**April 25, 2025
Addendum #2
FOR IMMEDIATE ATTENTION**

Reference – Invitation for Bid:	IFB #019-0-2025/SB Woodside High School Main Distribution Switchboards Replacement
For Delivery To:	Newport News Public Schools
Bids Due:	May 9, 2025 at 2:00 PM EST

ADDENDUM NO. 02

**Woodside HS Switchboard Replacement
Newport News Public Schools
IFB Project No. 019-0-2025SB
Newport News, Virginia
TCE # 21-163**

Woodside High School PV Interconnection Specification

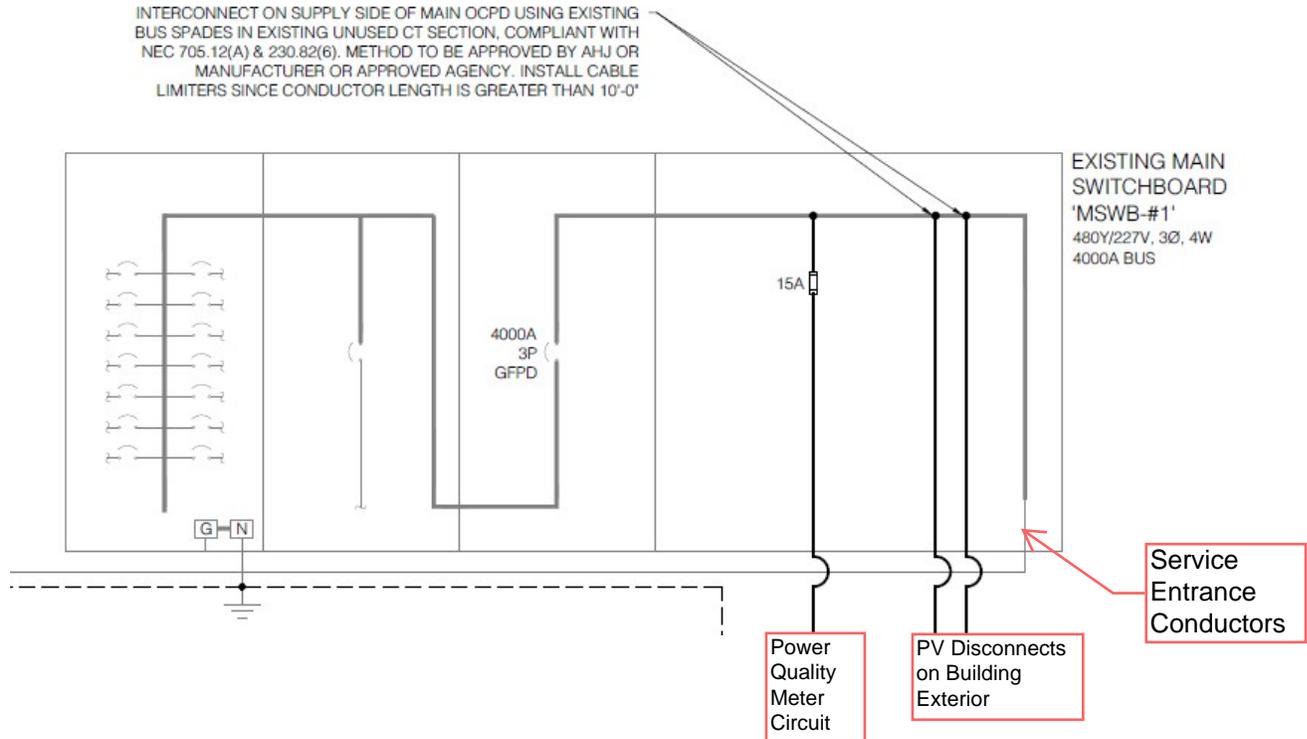
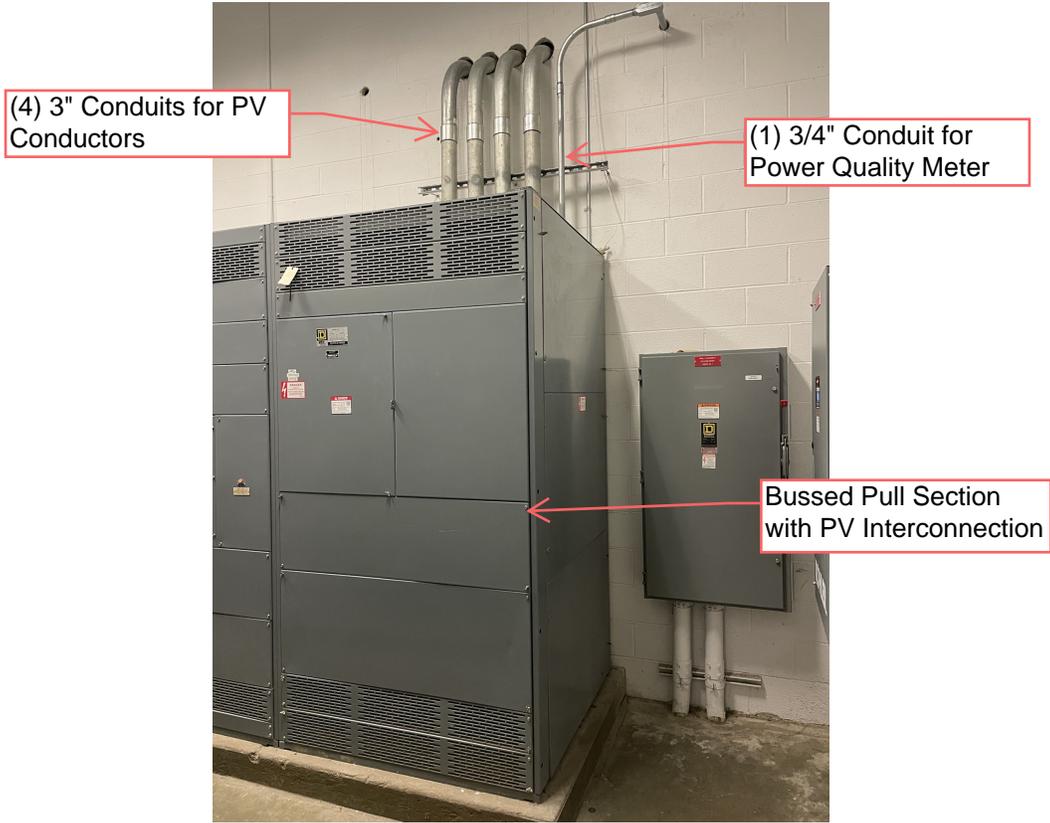
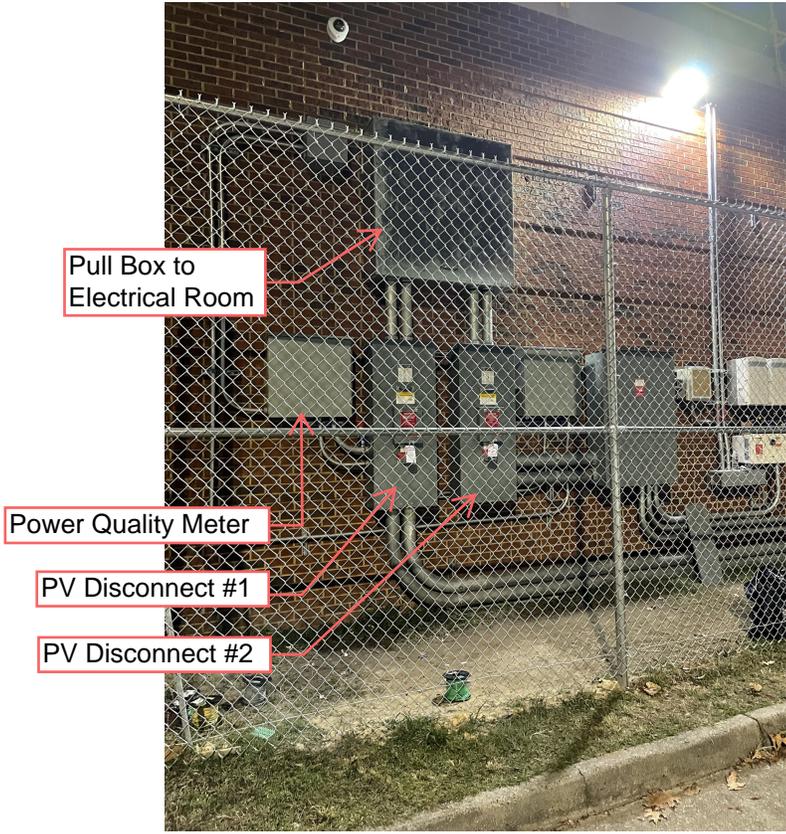
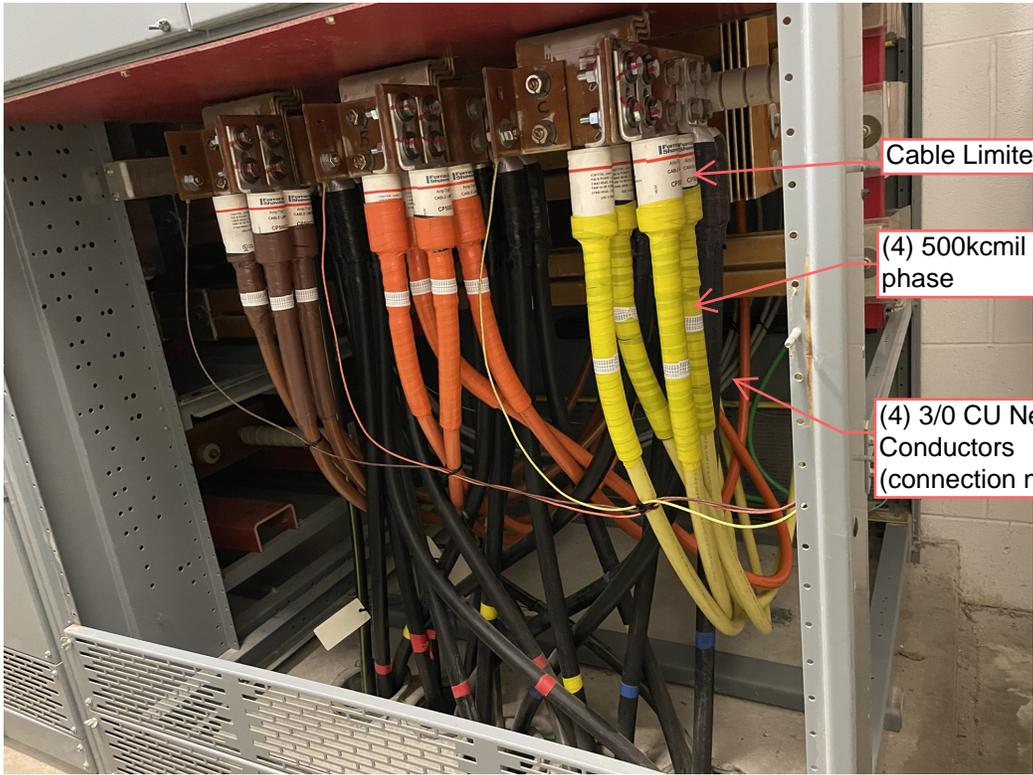
The 720kW PV system at Woodside High School terminates in the bussed pull section of the 4000A switchboard on the supply side of the main breaker. For the replacement of the switchboard, it is recommended that this supply-side interconnection method be maintained to ensure compatibility with existing PV conductors, cable limiters, and system layout. There are two 600A PV system disconnects and one Power Quality Meter circuit on the exterior of the building that are fed into the electrical room. Refer to As-Built electrical set for full system details.

- (4) 3/0 CU THWN-2 conductors
- Terminated with UL-listed compression lugs (2-hole NEMA pattern)
- Connected to the neutral bus using grade 5 hardware with flat washers
- Conductors shall be reused and re-terminated in the new switchboard as shown in the existing configuration

- (2) 2/0 CU THWN-2 conductors
 - Terminated to the ground bus using UL-listed compression lugs with 1-hole tongue
 - Each secured with a flat washer and torque-marked bolt to ensure proper mechanical and electrical contact
-

- Conductors shall be reused and re-terminated in the new switchboard as shown in the existing configuration

Cable Limiters

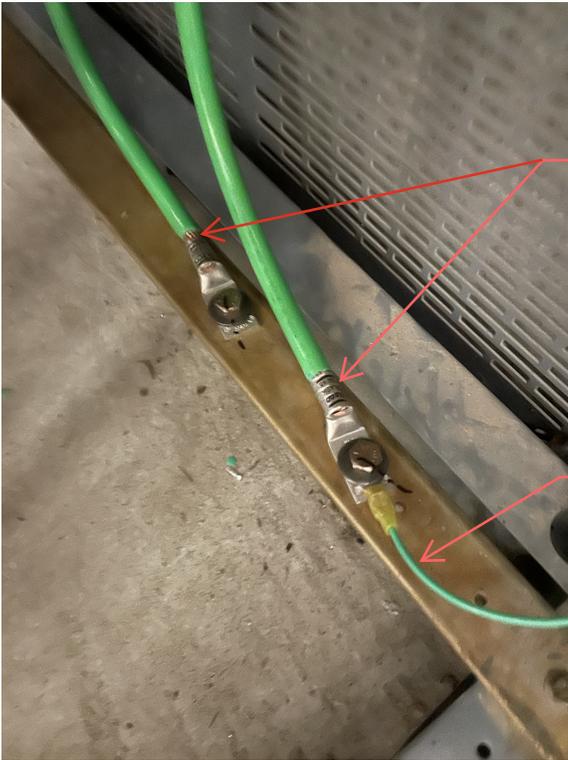
- (4) sets of 500 kcmil CU THWN-2
- Each terminated with a cable limiter
 - Includes NEMA 2-hole tongue for connection to copper bus
- Bolt stack shall include:
 - Grade 5 hex bolt
 - One flat washer (hardened steel or tin-plated copper) and one Belleville washer (spring washer, high-carbon steel alloy AISI 1074 or equivalent) per bolt
- Conductors shall be reused and re-terminated in the new switchboard as shown in the existing configuration

(4) 500kcmil CU per phase

Power Quality Meter
Grounding Conductor

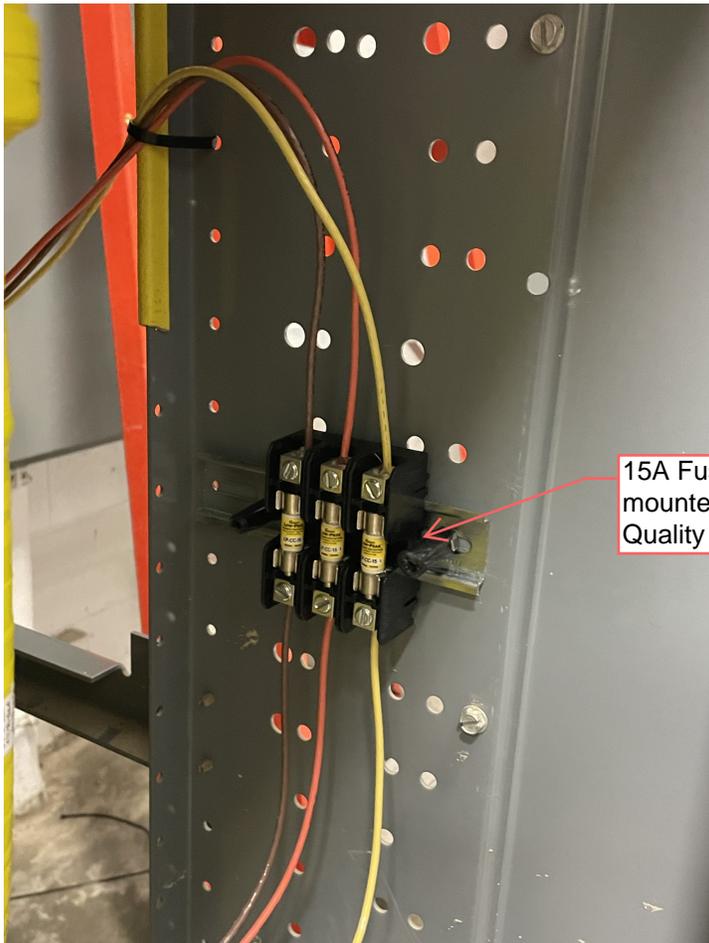
- Phase Conductors - (3) #12 CU THWN-2
- Neutral Conductor - (1) #12 CU THWN-2
- EGC - (1) #12 CU THWN-2
- Fusing:
 - (3) Class CC, 600V, 15A time-delay fuses
 - DIN-rail-mounted touch-safe fuse holders in switchboard bus section
- Wiring:
 - Reuse existing #12 CU THWN-2 conductors
 - Provide terminal blocks or wire lugs as needed to support termination of control and voltage sensing conductors within the switchboard interior
- These components support the voltage sensing and operational integrity of the revenue-grade Power Quality Meter and must be fully replicated in the new switchboard assembly.

15A Fuses - DIN rail
mounted for Power
Quality Meter Circuit
